**CITY OF CEDARBURG
A MEETING OF THE PLAN COMMISSION
MONDAY, MARCH 2, 2026 – 7:00 PM**

AGENDA

**CITY OF CEDARBURG
Plan Commission
February 2, 2026
Minutes**

TERRACE REALTY
 PROPOSED SMALL HOUSE
 SPRING STREET
 SHEET 1 OF 4 1/31/26

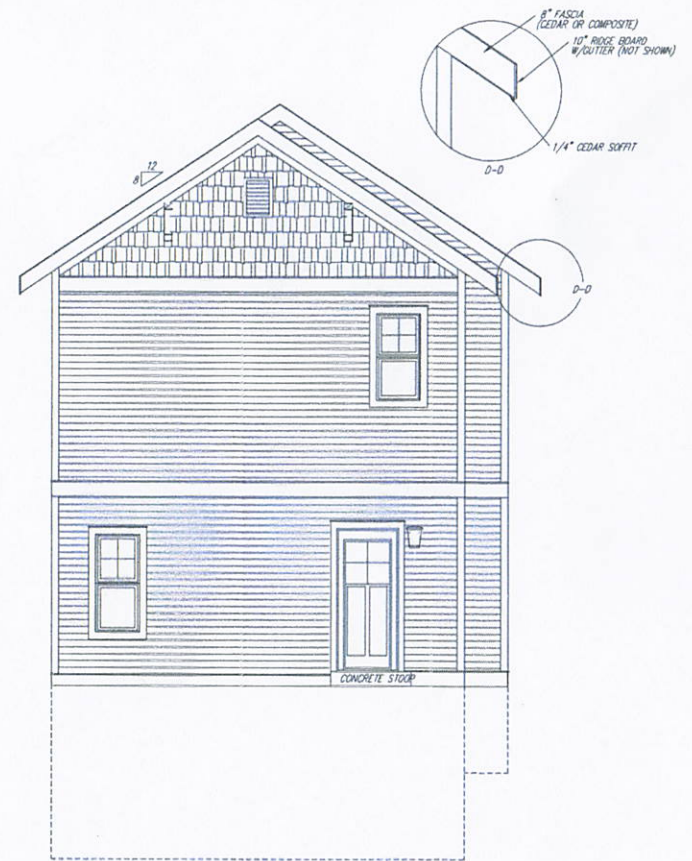
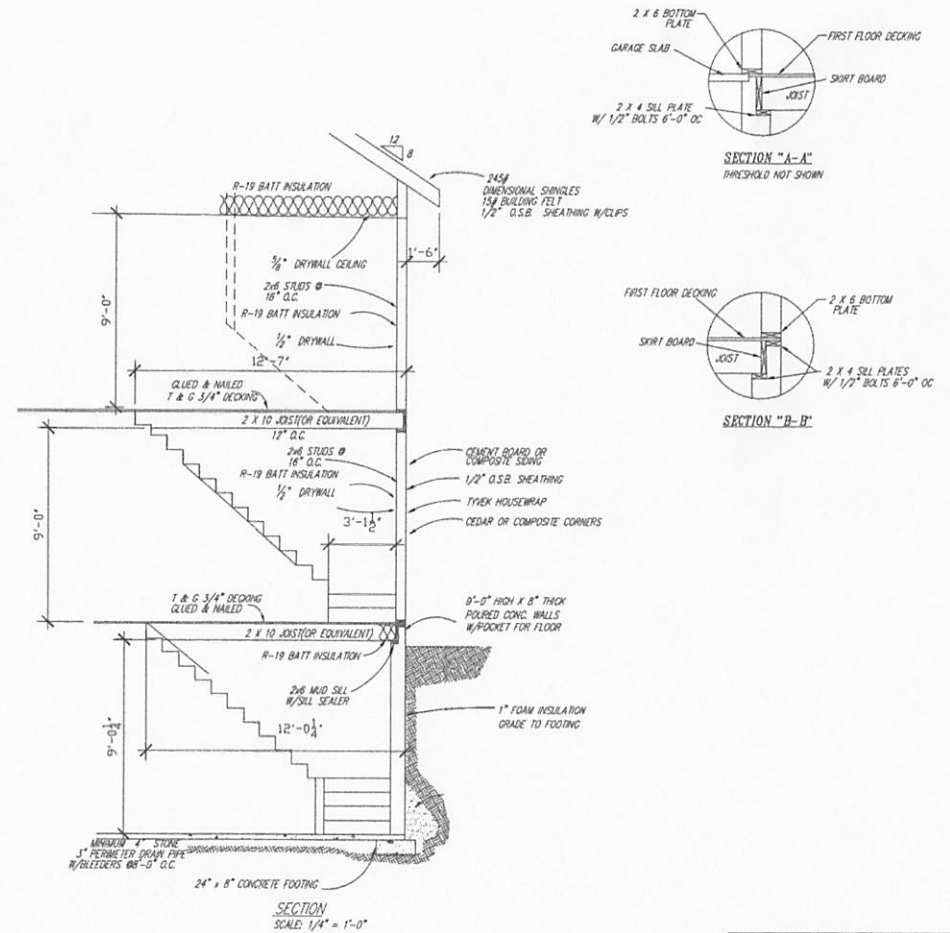
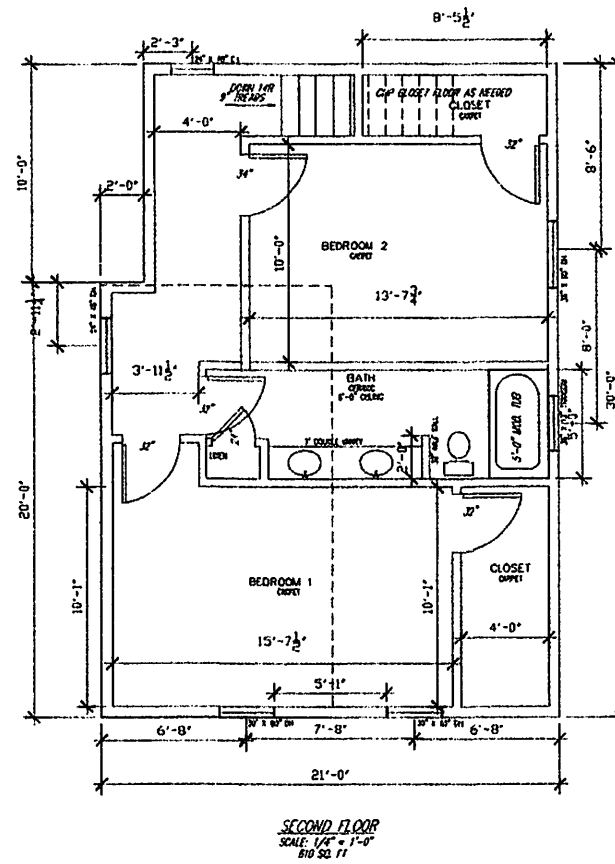
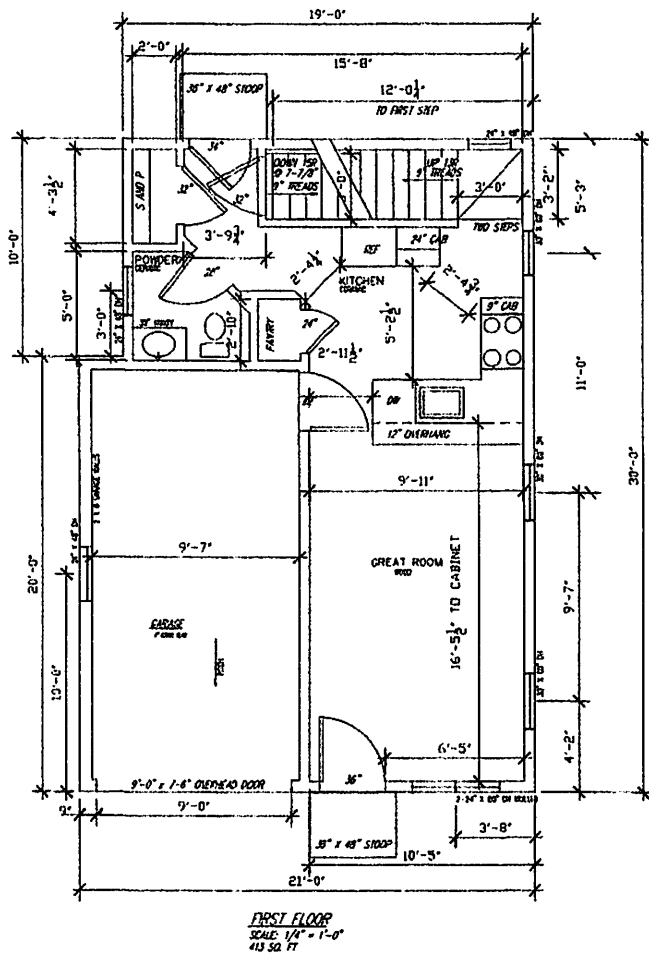
- 1) Extend the front awning style overhang across the entire front facade and/or add a modest, thoughtful front porch feature, even though it may create a bit more setback encroachment than the 20 feet.
- 2) Prior to issuance of Building Permit, applicant shall produce a current plat of survey to confirm that the house, as depicted by its floor plan, indeed fits onto the lot at a 20-foot setback, 3' west side setback, and 0' east side setback.
- 3) Plan Commission (with assistance if/as needed from City Attorney) shall determine that the applicant is indeed eligible to build this home as a replacement to the fire damaged, previously existing, legal nonconforming home/structure on this site.
- 4) Applicant to secure a variance from Board of Appeals as to the proposed <3-foot side yard offset for driveway if it cannot be reconfigured to comply.

- 1) Prior to issuance of a Building Permit, applicant shall:
 - a. Produce a current plat of survey to confirm that the house, as depicted by its floor plan, indeed fits onto the lot at a 20-foot setback (excluding the 5-foot deep attached front porch), 3' west side setback, and 0' east side setback.
 - b. Secure the approval of the City Engineer as to the plans for grading, drainage, erosion control, stormwater management, driveway access, and utilities in support of this plan.
- 2) Plan Commission (with assistance if/as needed from City Attorney) shall determine that the applicant is indeed eligible to build this home as a replacement to the fire damaged, previously existing, legal nonconforming home/structure on this site with/without a Board of Appeals variance as pertains to the small size and width of the lot.

In response to condition 1) above, the applicant has submitted a revised house plan. It is included in your packet of materials.

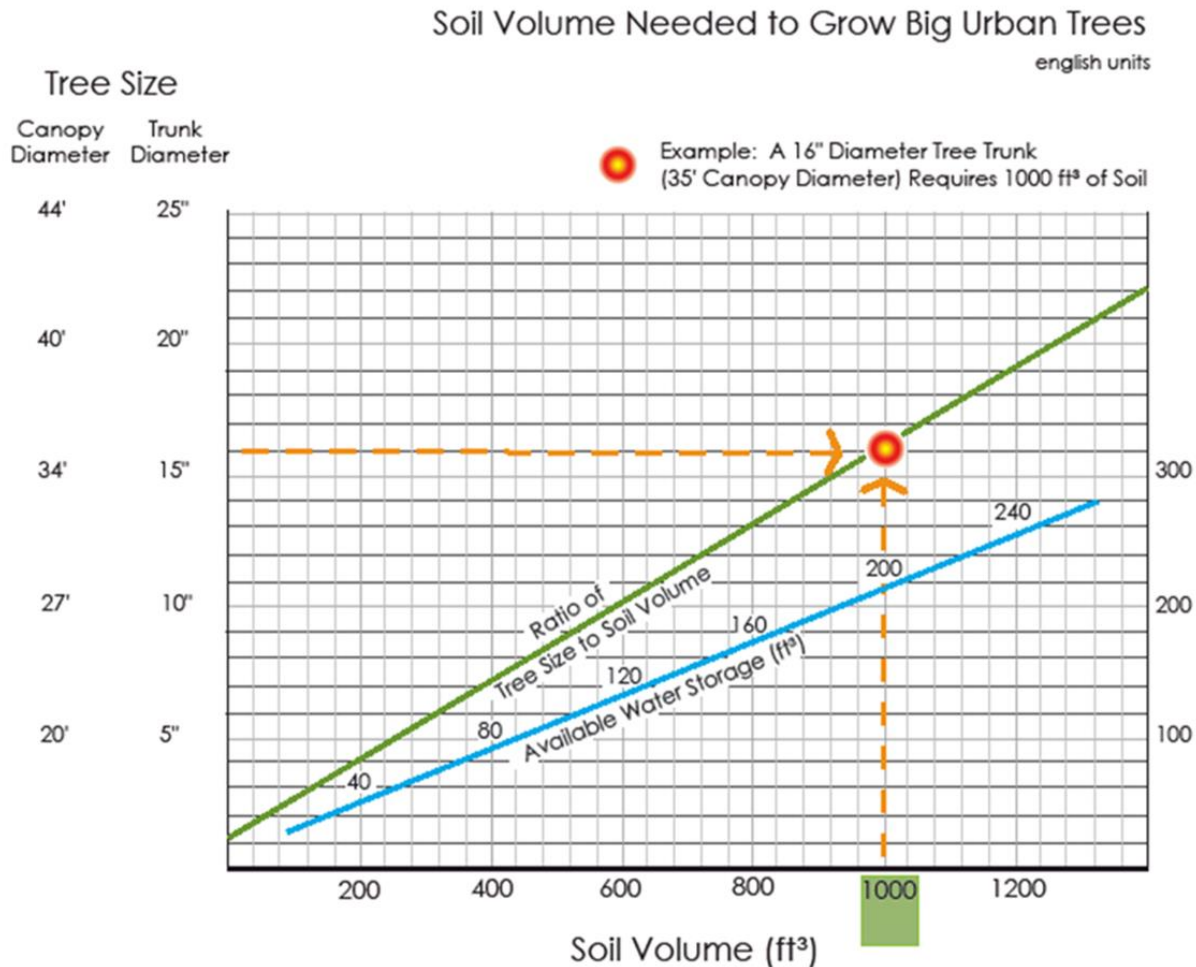
I respectfully ask the Plan Commission to consider requiring sixty-six foot (66') right-of-way (ROW) widths for all Minor Streets, and sixty foot (60') ROW width for all Cul-De-Sac Streets within the proposed Covered Bridge development north of Hwy. 60. This is consistent with the road ROW widths used in the Sandhill Trails subdivision.

In a typical 60 ft. ROW with a 32 ft. road surface, a 6-inch curb head and 5 ft. sidewalk, the grass strip known as the Parkway or Tree Terrace is 7 ft. wide. The benefit of requiring a 66 ft. wide ROW, assuming the road surface width stays the same, is the tree terrace now becomes 10 ft. wide.

A 10 ft. wide tree terrace would be a great benefit to the health and long-term survival of the street trees which will be planted along the new subdivision streets.

Gym

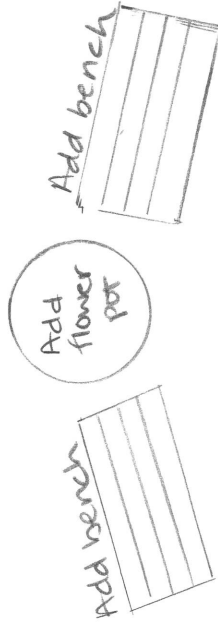
Remove red granite, make concrete
